TV

VOLUME 6

The question may be asked, "Why doesn't the manufacturer incorporate the cure into future production runs of his own receiver?" The answer is that he frequently does. However, it is certainly not possible, with such a complex device as a tv receiver, to hold off on production until every single "bug" has been removed. The fact remains that many receivers are in the field and do develop certain peculiarities of operation for which the manufacturer has a definite tried-and-tested cure. Many of these cures will be found in this volume.

Fig. 1 - Admiral

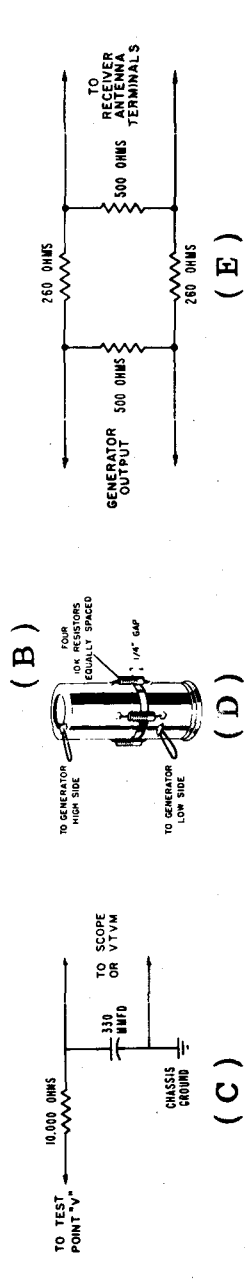
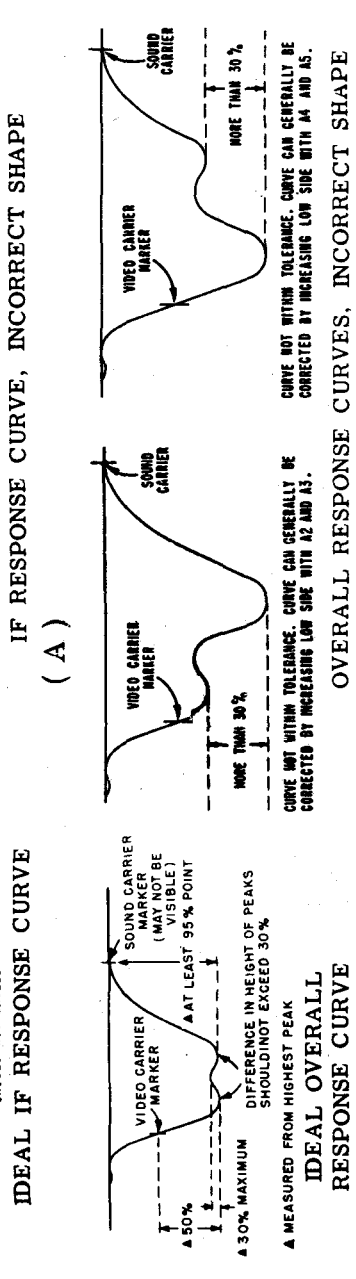
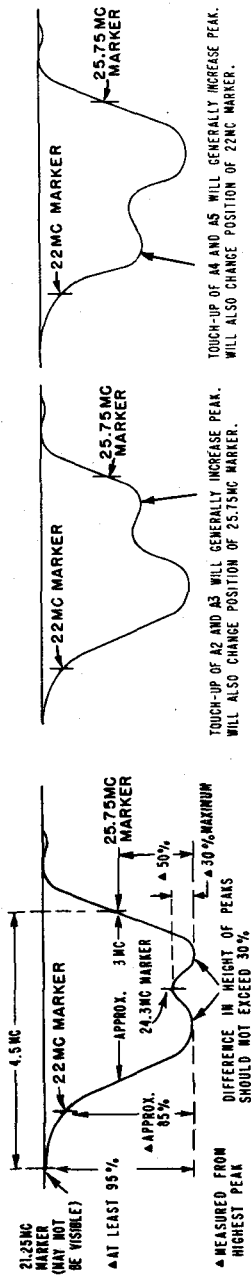
1. Instead of the original i-f response curves shown in the service notes, use the curves shown in part (A) of the figure. If it is necessary to adjust for approximate equal peaks and marker location, carefully adjust alignment slugs as instructed under the above figures. It should not be necessary to turn the slugs more than one turn in either direction. Note: Slug *A2* is the output transformer of 3rd i-f amplifier, slug *A3* is the input transformer of 2nd i-f amplifier, slug *A4* is the output transformer of 2nd i-f amplifier, and slug *A5* is the input tuned circuit of 1st i-f amplifier.

2. The overall response curves shown in the service notes should be changed. To correct the three curves, the dip in the curves shown near the baseline should appear on the left side of the adjacent sound channel trap (L301). The curves when corrected should appear as shown in part (B) of the figure.

When connecting a vtm or an oscilloscope to test point *V* (video detector load) as given under the alignment procedure, a decoupling filter consisting of a 10,000-ohm, $\frac{1}{2}$ -watt resistor and a 330- $\mu\mu\text{f}$ capacitor should always be used. This filter is connected in the manner shown in part (C) of the figure.

Fig. 2 — Admiral

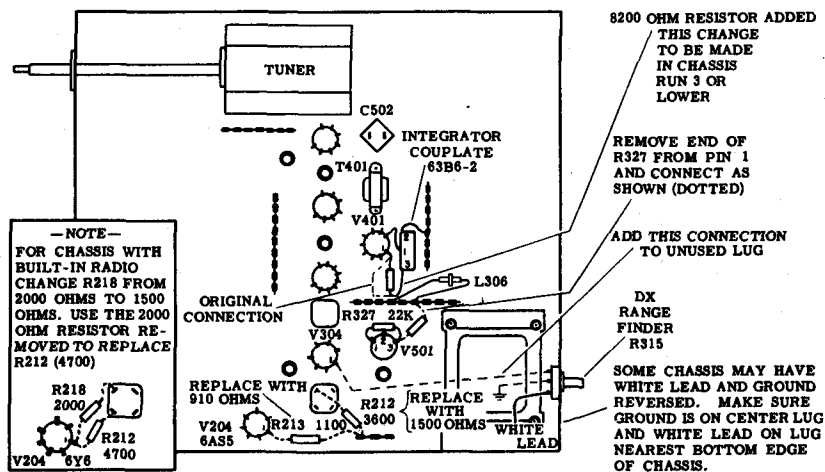
The horizontal stability of the 19-series chassis is improved with the use of a new vertical sync integrator Couplate, 63B6-11. The circuit of this Couplate is the same as the 63B6-2 Couplate used in chassis stamped Run 6 or lower, except that resistor *R407* (22,000 ohms) is not contained in this new Couplate. In-

stead, resistor *R407* is connected externally from terminal 3 of the Couplate to pin 1 of *V401B*. This change in integrator Couplates improves the horizontal sync stability by increasing the amplitude and “squaring up” the horizontal sync pulses.

This change represents a further improvement over that obtained with a Run 4 production change, which consisted of adding a 8,200-ohm resistor between terminal 3 of the Couplate and pin 1 of *V401B*.

To replace the old Couplate, 63B6-2, with the new improved Couplate, 63B6-11, omit *R443*, the 8,200-ohm resistor added at Run 4. Chassis stamped Run 3 or lower will not have this resistor. Connect *R407*, a 22,000-ohm, 1/2-watt resistor, 60B8-223, between terminal 3 of the new Couplate and pin 1 of *V401B*.

Fig. 3 - Admiral

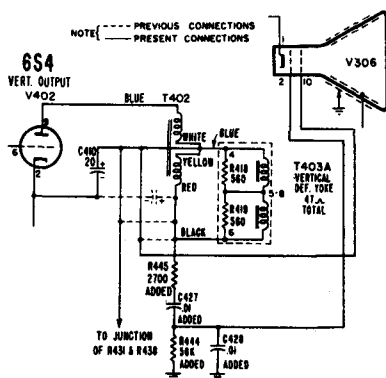
All 19-series chassis stamped Run 5 and higher have a vertical

retrace blanking circuit incorporated for eliminating retrace lines. A schematic of the retrace blanking circuit and detailed instructions for adding this change to an early production receiver, is given in the paragraphs below. The following parts are required:

3. Disconnect the red wire and the bare wire from their common junction point. Reconnect both of these leads to the junction of the 7.5-ohm winding and the 100-ohm winding of T402 (common point of the white and yellow leads). See figure.

Fig. 5 — Admiral

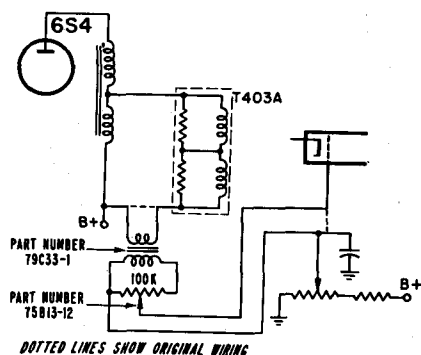
In some fringe areas, an increase in sound level can be obtained by detuning the 19.75-mc adjacent video channel trap *L108* (located between the plate circuit of the mixer and the grid circuit of the 1st i-f amplifier). When adjusting the fine tuning control on the re-

ceiver for best picture in fringe areas, the video i-f carrier moves to a higher position on the i-f curve and the sound carrier to a lower position. This places the sound carrier very near the frequency of *L108* and causes attenuation of the sound level. Therefore, by detuning the trap (*L108*), the sound level can be increased. Turn *L108* slug in about 1 or 8 turns or until no further increase in sound is apparent.

Fig. 9 — Admiral

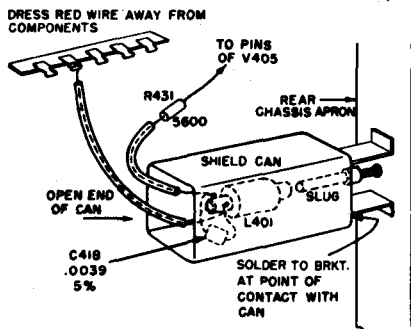
Horizontal ripple moving up or down in the picture is usually due to a power source frequency difference between the transmitter and the television receiver. It is caused by some of the 60-cycle power source voltage feeding into the horizontal oscillator. This a-c voltage can come from the B+ supply,

through the horizontal sync discriminator, and thus be applied to the control grid of the oscillator, or from flux leakage around the power transformer.

1. Disconnect the red lead from the lug on the horizontal lock coil (*L401*) and reroute it away from all chassis components. Reconnect the red lead to the lock coil lug. See the figure.

5. Slip the shield can over the slug, as shown in the drawing. The hole through the top of the can should be 7/16-inch diameter or larger.

Fig. 10 — Admiral

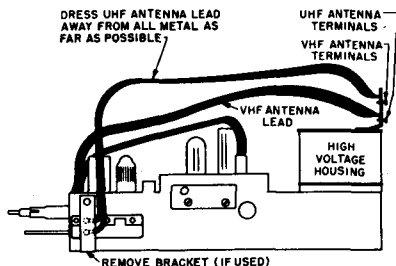
Poor performance of all-channel receivers on uhf may be caused

by the uhf antenna lead from the uhf antenna terminals to the uhf tuner being close to or touching the metal brackets of the rear picture tube mount. This lead is purposely long and acts as a quarter-wave trap at the mean frequency of the higher vhf channels.

Remove the back cover of the cabinet and check this lead to be sure it is not close to any metal and straighten it out if it is looped or doubled up. While the back is off the cabinet and after the antenna lead has been checked, check the lead from the uhf antenna terminals at the point where it is soldered to the side of the uhf tuner; see illustration. Remove the metal bracket (if used) that covers the uhf antenna connections. This bracket was used on the production line and is not required after the set is installed in the cabinet.

Fig. 12 - Arvin

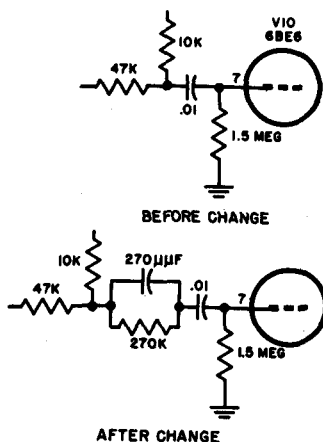
A definite improvement in overall sync stability under the presence of impulse-type noise interference in

fringe areas can be accomplished by lowering the screen voltage on the video amplifier, *V10* from 110 volts to 60 volts. Although this change may introduce a slight decrease in picture contrast, this should not prove to be detrimental on a comparison basis. The following additional parts are needed: a 4- μ f, 300-volt electrolytic capacitor and a 91 k-ohm, 1/2-watt resistor.

2. Remove this wire from lug and reroute wire to blank lug of adjacent terminal strip, 1 inch away.

3. Add a 91k-ohm resistor between the old lug (110-v supply lug) and the new lug.

4. Add a 4- μ f capacitor between the new lug and the chassis ground lug connected to pin 7 of *VII*.

Fig. 15 - Arvin

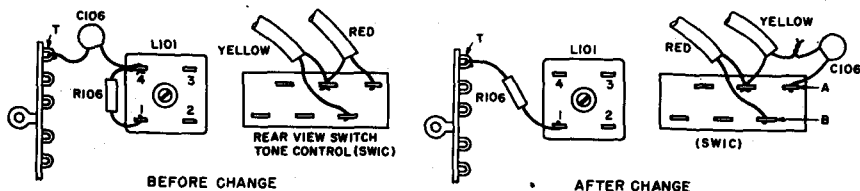
The purpose of this change was to improve the stability of the sound detector circuit by broadening the tuning of quadrature coil *L101*. The specific defect being corrected was the tendency of *L101* to drift off re-

sonance after warm-up, causing distorted sound.

1. Remove C106 from lug 4 on L101 and T on terminal strip.

5. Add C106 from yellow wire in step (3) (connection made in space) to A on SWIC.

Fig. 20 — Capehart

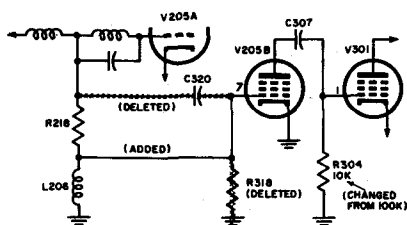
This change is incorporated in later production to eliminate the

sometimes apparent objectionable frying or hissing in the sound under extremely weak signal conditions. To make this change on early production chassis:

Fig. 25 — Conrac

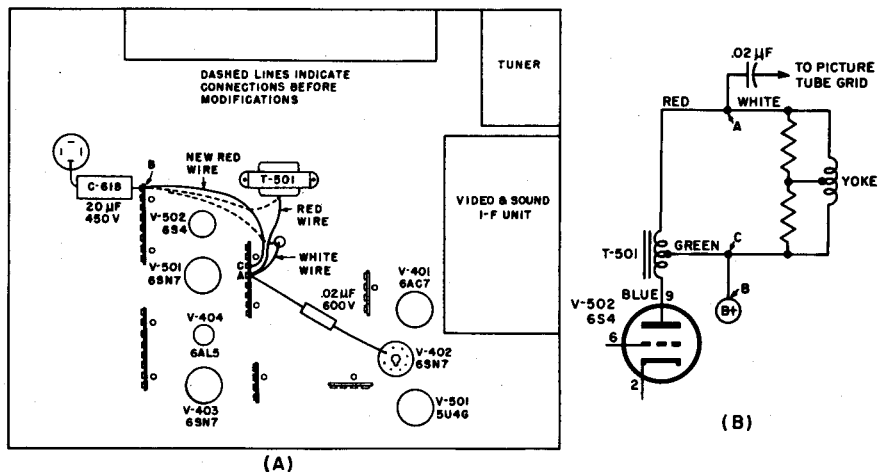
2. Remove red wire leading from *T501* (vertical output transformer)

from tie point *B* (*B+* boost) and reconnect to tie point *A*.

Fig. 27 - Crosley

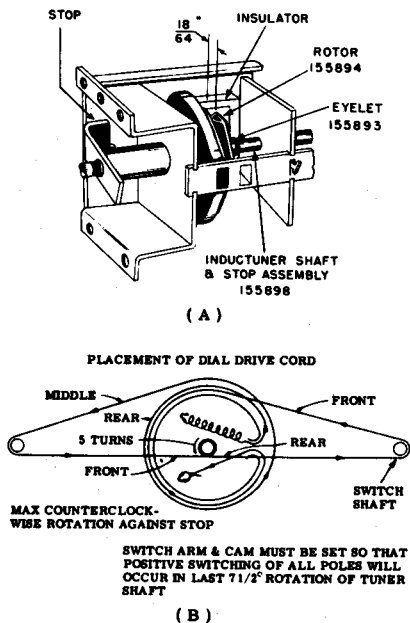
Repairing damaged tuning mechanism (see Fig. 27).

The shafts and the fiber hub used in these converters have sufficient strength and flexibility to withstand normal handling and use. However, if a receiver is moved by grasping the control knobs, or if shafts are severely bumped or jar-

red, it is possible for the tuning mechanism to become damaged. Generally, the resulting damage will be a broken fiber hub on the control knob shaft or a loose stop on the knurled portion of the Inductuner shaft.

Fig. 34 - Crosley

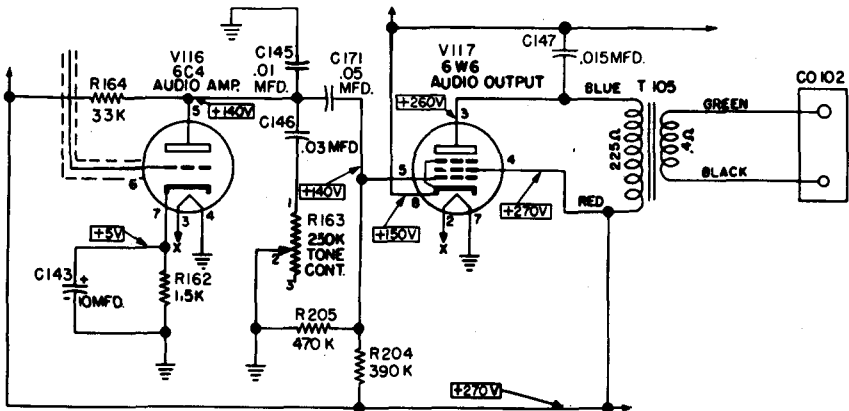
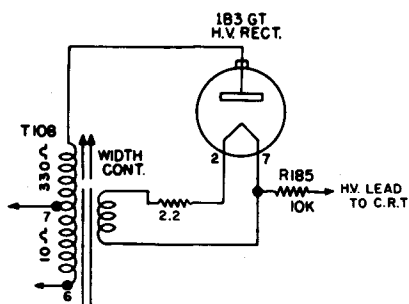
To reduce horizontal distortion at high brightness levels, a capacitor (.01 μ f, 600 v, paper) is deleted from 24-inch and 27-inch chassis. It was formerly wired from *TP-3* (green lead) to ground. See the fig-

ure and the schematic wiring diagram of the chassis involved. The change is already made in later production.

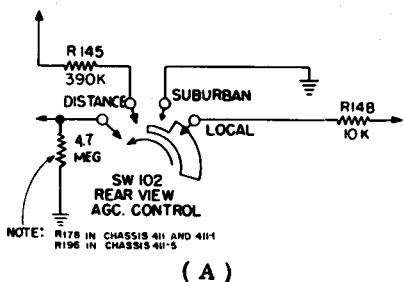
Improvement in sync stability (see Fig. 36).

In the above chassis, a 4.7-meg-ohm, 10%, 1/2-watt resistor (part No. 39374-77) is added to improve sync stability with the action of the agc

Fig. 37 — Crosley

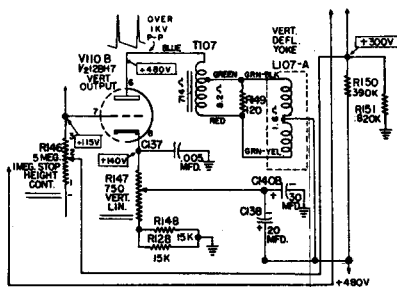
An improvement in the screen grid circuit of the horizontal output tube of the 24-inch chassis is made by adding a 1,800-ohm, 10%, 2-watt resistor (part No. 39374-204) in series with the other screen dropping resistor or resistors. It is added to guard against excessive high voltage in the above chassis. The change is already made in later production.

deflection coils. The colors for these two leads as shown in the schematic in the receiver service notes are incorrect.

Fig. 38 — Crosley

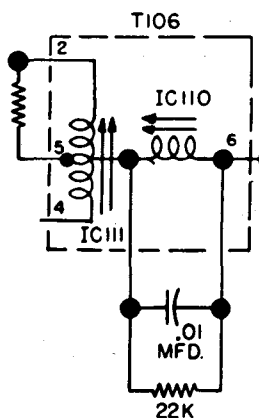
Mounting the magnets. The upper magnet may be mounted using the center hole in the flange at the top front of the deflection yoke bracket. The lower magnet may be mounted by soldering the end of the support strap directly to the deflection yoke bracket. It should be positioned so that the hole in the end of the strap is located on the vertical center line of the bracket and approximately 1¾ inches below the bottom edge of the large hole provided for the tube neck. An alternate method is to drill

a small hole in the deflection yoke bracket at this point and secure the magnet to the bracket using a suitable nut and bolt.

Fig. 39 — Crosley

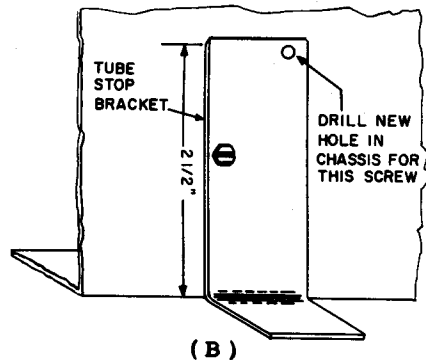
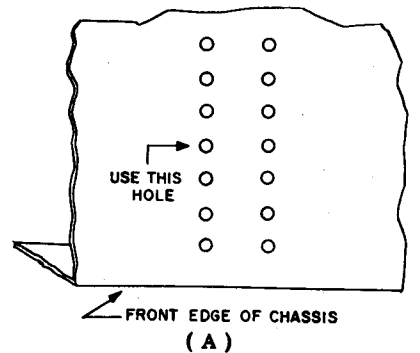
If horizontal drift is experienced due to humidity, replace the .01- μ f
